Subject: AP1000 Response to Request for Additional Information (SRP TR85 and 3.8.3)

AP1000 TECHNICAL REPORT REVIEW

Response to Request For Additional Information (RAI)

RAI Response Number: RAI-TR85-SEB1-10
Revision: 5

Figure RAI-TR85-SEB1-10-1 – Passive Pressure versus Deflection at Grade (North-South Excitation)

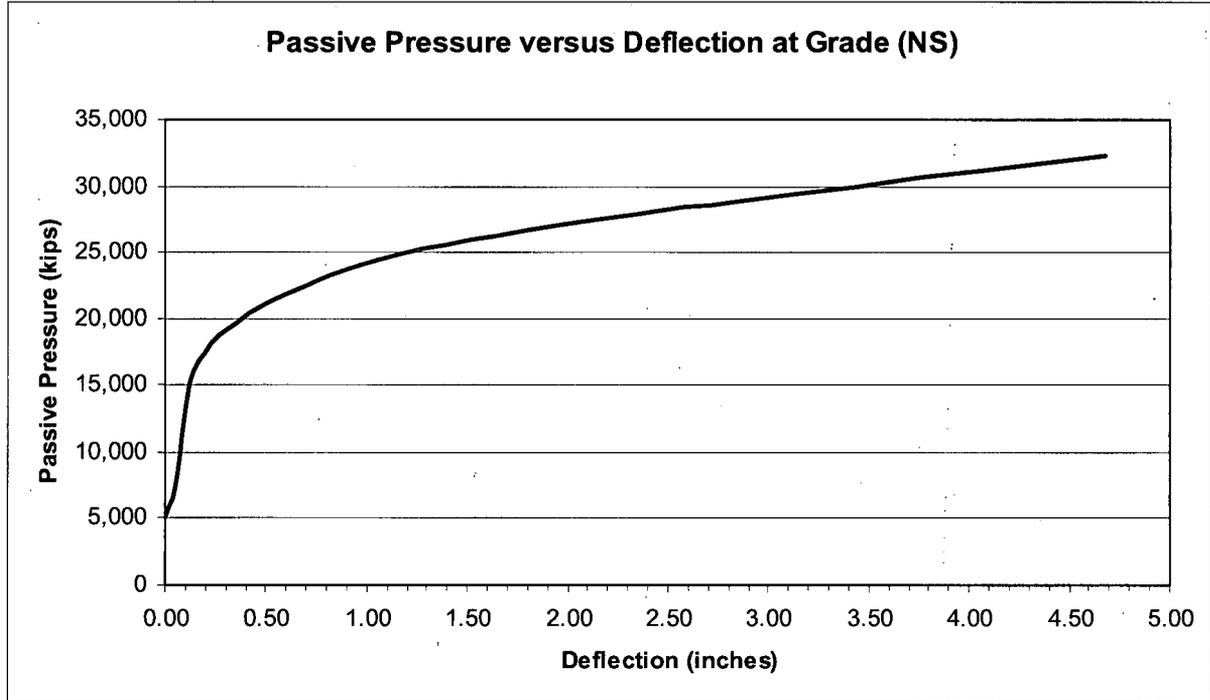
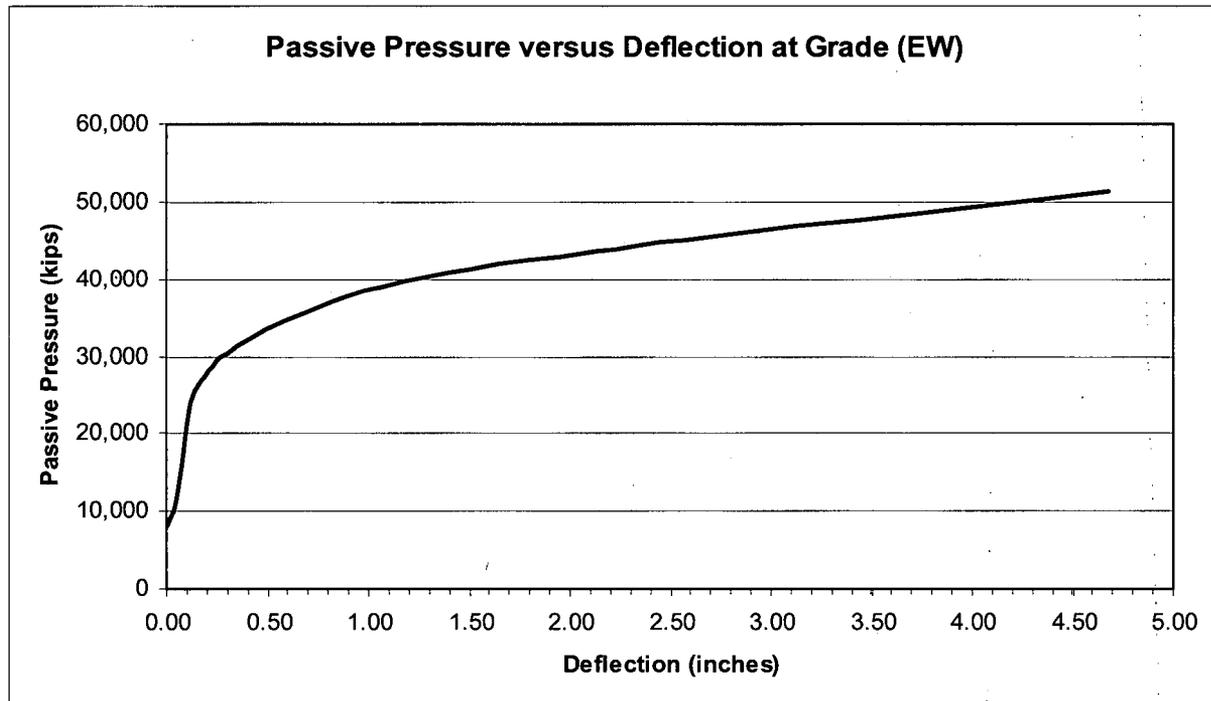
In the response for item b of the RAI, Westinghouse indicated that the analysis for stability has been revised to utilize the 3D ANSYS finite element NI20 model using a mode superposition time history analysis (linear with no lift-off). A separate 2D ANSYS lift-off analysis demonstrated that the minor lift-off is negligible. Since the 3D ANSYS NI20 model analysis using three input motions applied simultaneously is utilized for the stability evaluation, the concern raised by the directional combination methods no longer applies. Therefore, this concern has been adequately addressed. However, the RAI response discussed the need to utilize some passive pressure resistance capability of the soil when performing the sliding stability analyses. The passive pressure resistance curve as a function of displacement is based on Reference 1 (Hsai-Yang Fang, "Foundation Engineering Handbook," 1991) given in the RAI response. Westinghouse is requested to provide the complete text in the applicable section or chapter of the referenced book which describes the approach for determining the passive pressure resistance function.

- a) The staff reviewed the response provided in Westinghouse letter dated September 22, 2009 and found that insufficient information was provided. In the response, the passive earth pressure was removed from the seismic stability analysis, an explanation was provided why reliance on soil passive pressure is not required for stability evaluation, and related tables were revised in the corresponding subsections of the DCD and TR-85. This information is subject to an audit for its adequacy.

In the May 4 to 8, 2009 audit, the NRC reviewed the displacements based on the displacement curves given in Reference 1. The displacements given in the Revision 1 response to this RAI is based on the passive pressures defined using the Case 15 soil parameters as defined in RAI-TR85-SEB1-35. As part of the review of RAI-TR85-SEB1-35, the NRC requested Westinghouse to explain why, for sliding stability evaluation, a high passive pressure was used for resistance of the backfill adjacent to the Nuclear Island (NI) rather than a lower bound value based on soil parameters such as those defined by Case 21 (soil parameters defined in RAI-TR85-SEB1-35). Westinghouse stated that a lower bound was used in for the soil properties similar to Case 21. A comparison of geotechnical parameters and lateral earth pressures was given during the audit and is presented in Table RAI-TR85-SEB1-10-6. Presented in Tables RAI-TR85-SEB1-10-7 to RAI-TR85-SEB1-10-12 are the stability results for Case 15 and the lower bound soil case evaluated. It is noted that the displacements given for Case 15 are slightly different from those given in Revision 1 of this response because the active and dynamic surcharge pressures were slightly modified to be more representative (e.g. dynamic surcharge acting only on one side; active pressure acts below adjacent building foundations). The deflections obtained were discussed. It was stated by Westinghouse that the analysis methodology used was the conservative equivalent static. This will result in large deflections since the seismic loads are considered to be constant and do not reflect the short time duration

Therefore, it can be concluded that the Nuclear Island is stable against sliding, and there is no quality requirement for the backfill material adjacent to the NI (side soil) to remain stable against sliding. Also, as noted in Revision 1 of this response, there is no passive pressure required to maintain stability against overturning.

Figure RAI-TR85-SEB1-10-3 - North-South FS without Passive Pressure

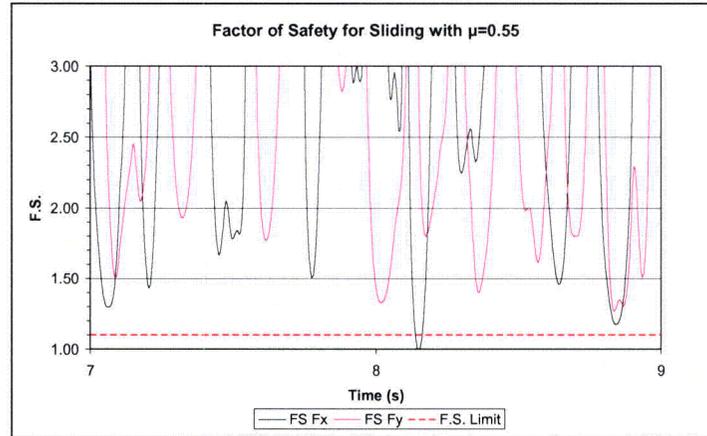
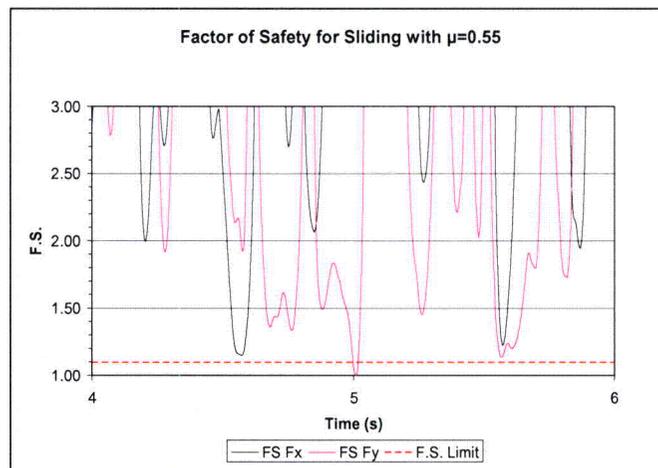
It is requested that changes in the nuclear island seismic sliding displacements due to modifications of the non-linear seismic sliding model be reflected in this RAI.

During the sliding stability calculation it was determined that the factor of safety for sliding drops below the limit of 1.1 for a very short time if passive pressure is not considered. Plots of the factor of safety (FS) versus time for the hard rock case and the North-South and East-West directions are given in Figures RAI-TR85-SEB1-10-3 and RAI-TR85-SEB1-10-4 using a coefficient of friction of 0.55. As seen from these figures the time at which the factor of safety drops below 1.1 is very short. This is the only time during the seismic event that this occurs. When the passive pressure is considered, the factor of safety remains above the limit of 1.1.

Figure RAI-TR85-SEB1-027-01 Soil Reaction Forces on Section B-B

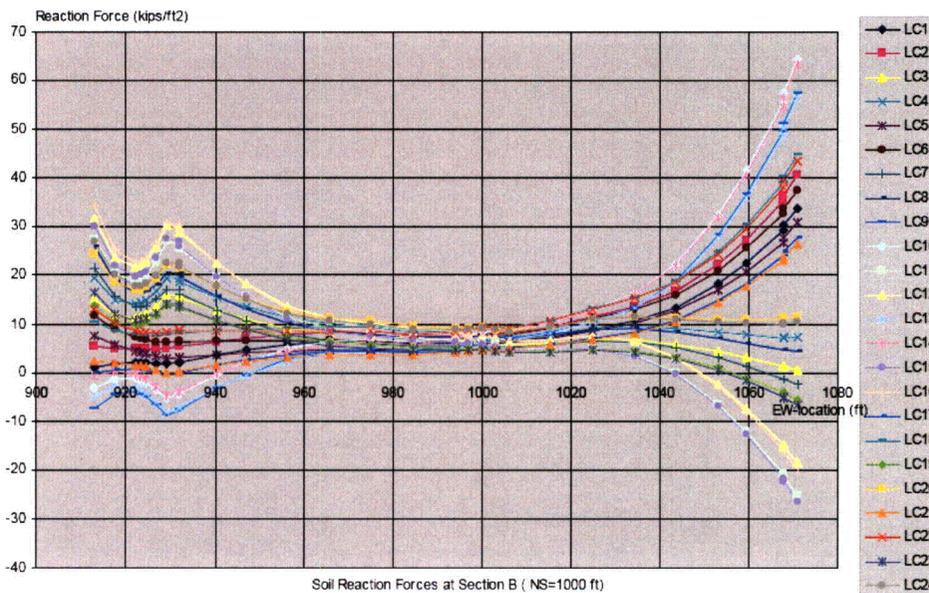
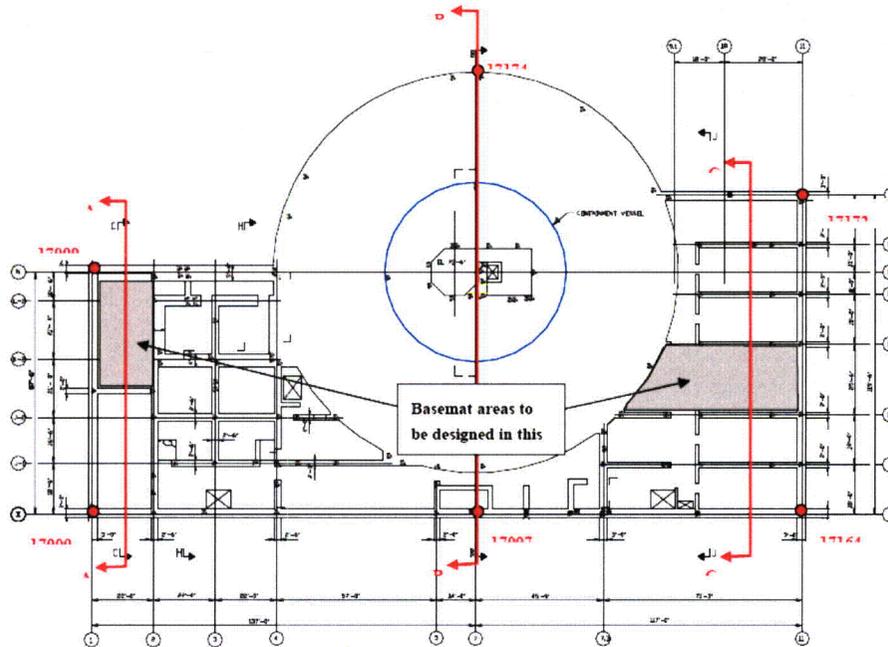
The response explains that the non-linear analyses were not performed for the cases with 1.0 applied in the vertical direction since the maximum bearing demand is due to overturning rather than vertical seismic. It is not evident that this would always be the case. Please explain.

Linear analyses were performed for all 24 cases of the 100/40/40 combination method in the initial hard rock analyses and used to select the 16 cases analyzed in subsequent non-linear analyses. Typical results are shown in Figure RAI-TR85-SEB1-027-01. The cases with unit load factor in the vertical direction are load cases 17 to 24. The following 16 cases for the 1.0, 0.4, 0.4 method were used. Non-linear analyses were not performed for the cases with 1.0 applied in the vertical direction since the maximum bearing and member force demand is due to overturning rather than vertical seismic.

Figure RAI-TR85-SEB1-32-1
Comparison of Vertical Stress at Basemat Bottom Node – No embedment

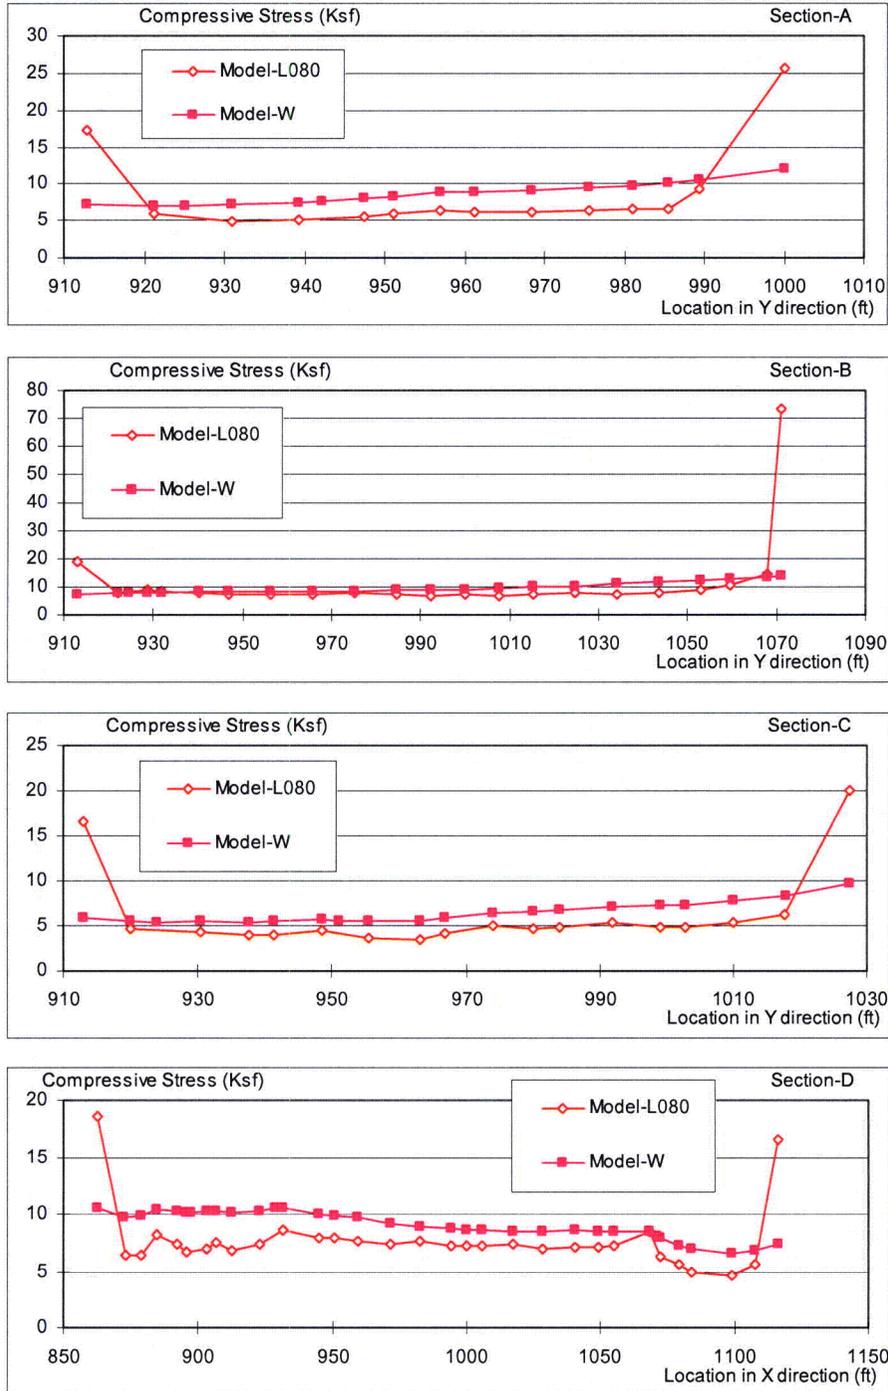
As shown by the studies in Section 2.7.1.2.1, when the soil is represented as solid elements rather than Winkler soil springs, higher bearing pressures occur at the edges and lower bearing pressures away from the edges. This is referred to as the effects of the Boussinesq distribution. Although this indicates that the basemat slab away from the walls would have higher bearing pressures using the Winkler soil spring approach (see Figure 2.7-2), the calculation of the maximum bearing pressure would still exist at the building edges if the soil is modeled as solid elements. Therefore, explain why the maximum bearing pressure for the AP1000 design, discussed in Section 2.4.2, should be based on the 2D ANSYS nonlinear dynamic analysis using Winkler soil springs rather than solid soil elements?

1. Clarify the Model identification in Table RAI-TR85-SEB1-32-1, Line 2 and Line 3. Consider use of description in Appendix 3G.
2. In the second paragraph on page 4 of 13 of the RAI response how does the referenced report from section 2.7.2 of TR85 demonstrate the acceptability of using Winkler springs instead of the method using Boussinesq effect.

Figure RAI-TR85-SEB1-32-1 shows bearing pressures due to dead load. The sections are located as shown in Figure 2.7-2 of the technical report. The RAI figure only shows the two cases identified above. The finite element soil model shows high local bearing pressures close to the edge. This is due to the Boussinesq effect. The higher pressures at the edge result in lower pressures away from the edge. Figures RAI-TR85-SEB1-32-2 and 3 show bending moment contours MX and MY for these two cases. It is seen that the bending moments for the soil spring case are higher than those for the soil finite element model even in the bays immediately adjacent to the edge.

1. The 2D SASSI model listed at Line 2 of Table RAI-TR85-SEB1-32-1 refers to the East-West 2D stick model described in section 2.4.1 of APP-GW-GLR-044, and also shown in Figure 2.4-2 of that report. The 2D Time History model listed at Line 3 of the table refers to the lift-off analysis performed in ANSYS described in section 2.4.2 of APP-GW-GLR-044, and shown in Figure 2.4-4 of that report.

Figure RAI-TR85-SEB1-32-2 Bending Moment MX for Model-W and Model-L080

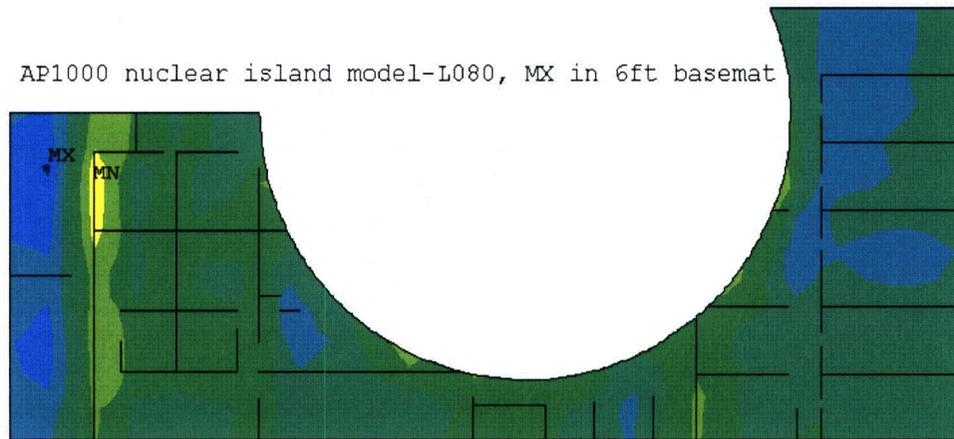
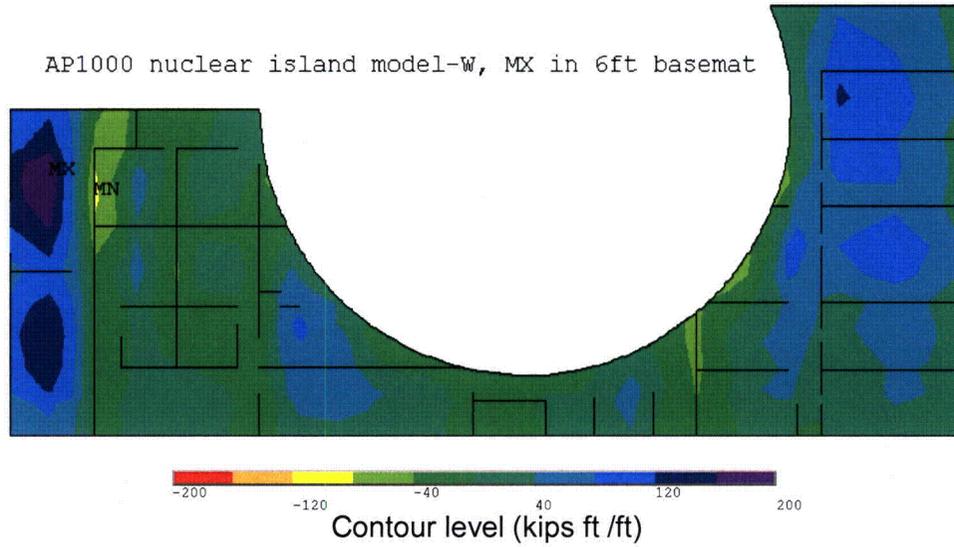
The staff reviewed the Westinghouse response to RAI-TR85-SEB1-32, Rev. 3 and determined that Item 2 of the response did not adequately address staff's concerns. The information provided does not clearly demonstrate that the bending moments and shear forces in the basemat using the Winkler soil springs are acceptable. For example, as shown in Figures RAI-TR85-SEB1-32-2 and 3 provided in Revision 2 to this RAI, there are locations where the bending moments using the finite element model are larger than the results for the Winkler soil spring model. Therefore, provide the technical basis for using the Winkler soil spring model. The technical basis should include tabulated or plotted curves (not contour plots) showing moments (positive and negative) and shear forces at locations in the basemat that govern the design for the rest of basemat.

Figure RAI-SRP-3.8.3-SEB1-04-01
Representative details at base of CA01 Module Wall with a Double Layer of Dowel Bars

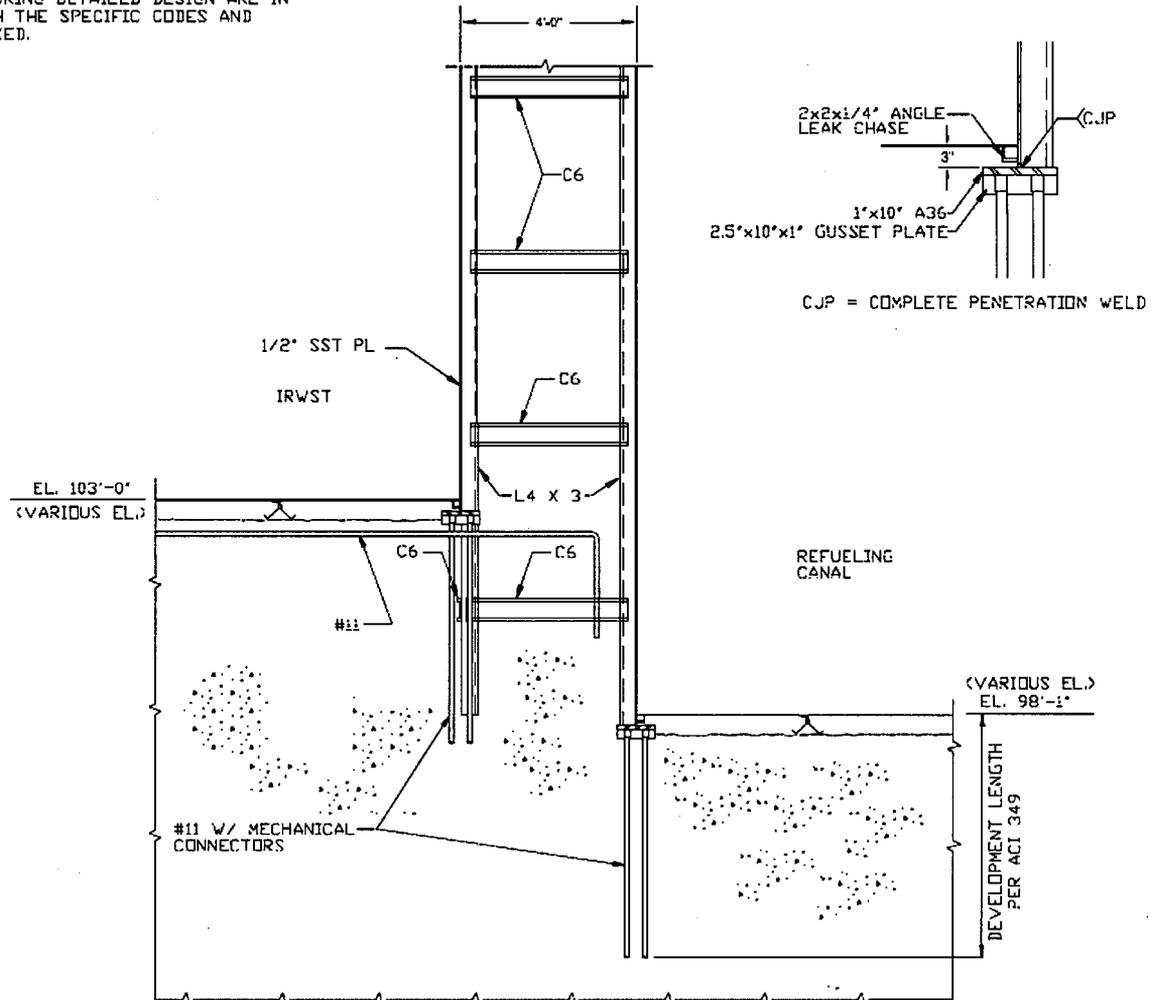
1. The left side of Figure 3.8.3-8, sheet 2, shows that the mechanical connectors that are welded to a $\frac{3}{4}$ inch plate at the base of the module is identified as "CONT" (presumably meaning continuous) on one side of the module and on the other side the term "CONT" is struck out. Explain which detail is correct and revise the figure accordingly. Were the design detail calculations completed for this connection? Explain how the large loads coming from the CIS wall modules can be properly transferred from the module wall plate at a localized point to the embedded connectors.

2. The right side of Figure 3.8.3-8, sheet 2 shows #11 at 10 inch spacing span from the embedded basemat region into the wall module with about 3 inches of concrete cover. Since this type of connection is not addressed in ACI 349, describe how the loads from the module can be properly transferred from the module to the embedded bars in the basemat and how the design will be performed. When this detail was discussed with Westinghouse at an earlier audit this year, Westinghouse indicated that they would consider removing this second option.

For the updated DCD Figure 3.8.3-8, Sheet 2, provided in the RAI response, explain why the left hand side connection detail was replaced with the new connection detail shown in Figure RAI-SRP-3.8.3-SEB1-04-01A, rather than replacing the right hand side connection detail. This is not consistent with the text information provided in the RAI response.

Westinghouse will remove the "alternate" detail with the lapped splice, and provide mechanical connection of the structural modules to the base concrete using reinforcing bars and mechanical connectors. The mechanical connection detail illustrated in Figure RAI-SRP-3.8.3-SEB1-04-01 is representative of the connection that will be used. This mechanical connection consists of a base plate welded to the CA module liner plate, with gusset plates and vertical reinforcing bars attached to the underside of the base plate. DCD figure 3.8.3-8 is modified to reflect changes to the connection, including deletion of lap splice details. The details presented as typical are intended to provide clarity of the design intent, but not to supersede any changes necessary to accommodate features needed to ensure functionality of the design.

Figure RAI-SRP-3.8.3-SEB1-04-01 in the previous response is replaced by a revised Figure RAI-SRP-3.8.3-SEB1-04-01 which includes revisions to respond to the previous comments. The items listed in the question related to the revised typical detail shown in Figure RAI-SRP-3.8.3-SEB1-04-01 (Figure 01A in Rev 1 response) are addressed below.

1. The horizontal #11 @ 18" rebars are incorrectly identified with mechanical connectors. These bars terminate with hooks as shown in the sketch. This figure has been revised.
2. The enlarged detail in the upper right corner shows a section midway between the vertical L4 x 3 angles. As shown in Figure 3.8.3-SEB1-04-02, the base plate is not continuous across the vertical angles. This design will be clarified in implementation of the changes described in this response.
